W0231-01
Sub 48

Re: Waste Licence Application W 0231-01 Fingal Landfill

Objection By: Kevin Cullen

A review of Geological and Hydrogeological Sections (Vol. 5) of the EIS accompanying the above licence application indicates that there are a number of significant omissions and inaccuracies in the published document.

Figure 3

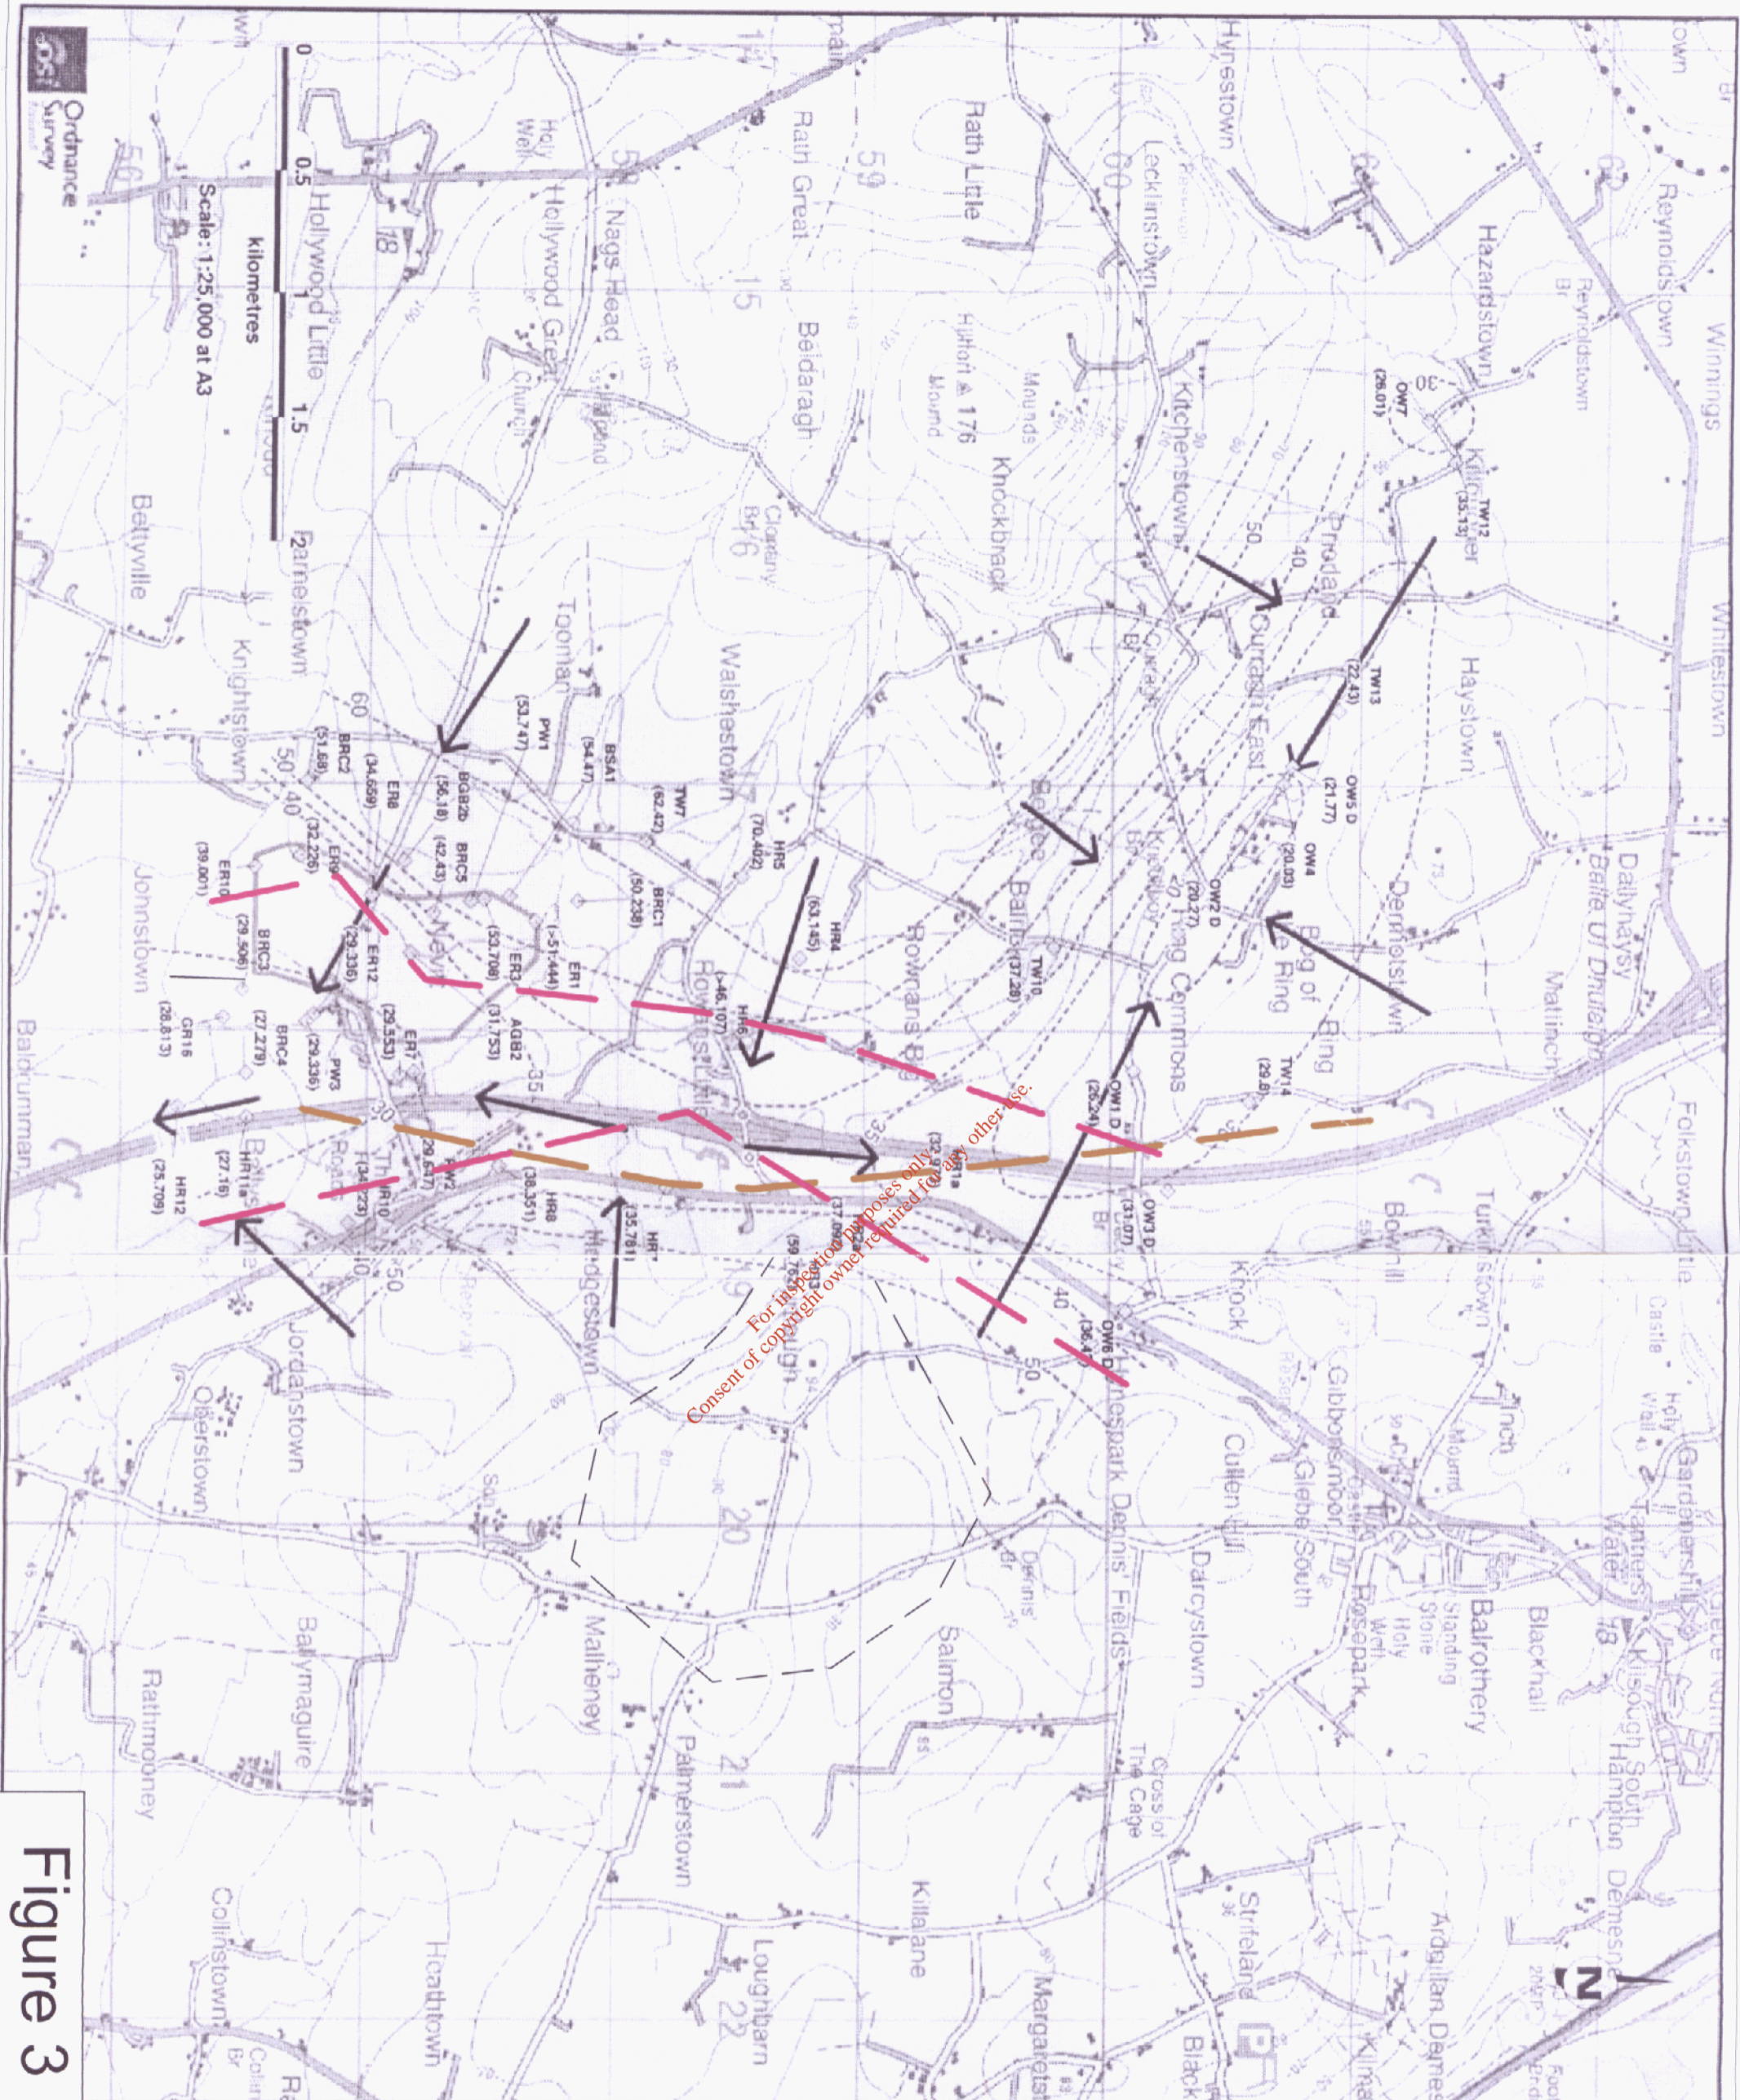
The accompanying Figure 3 superimposes the fault zones derived from the analysis of depth to bedrock presented in the accompanying Figure 2.

It is clear that the fault zone is seen to impart a major control on the bedrock groundwater flow patterns presented in the EIS by the Applicant in Appendix A5 of Volume 5. Note also the dramatic change in the groundwater gradient in the south west of the planned footprint area which coincides with the western edge of the fault zone.

Clearly, the proposed fault zone represents an area of increased permeability as demonstrated by the preferential flow of groundwater in the bedrock to and along this zone.

Note how the fault zone is acting as a regional conduit for groundwater movement. The fault zone collects groundwater from both the east and west and then channels the groundwater to flow both to the north and south of borehole HR13b.

Conclusion: A revised EIS should be published with a map at a scale of 1:10,000 showing the distribution of zones of high permeability at Nevitt and an analysis of how these zones control the groundwater flow patterns beneath the landfill footprint.
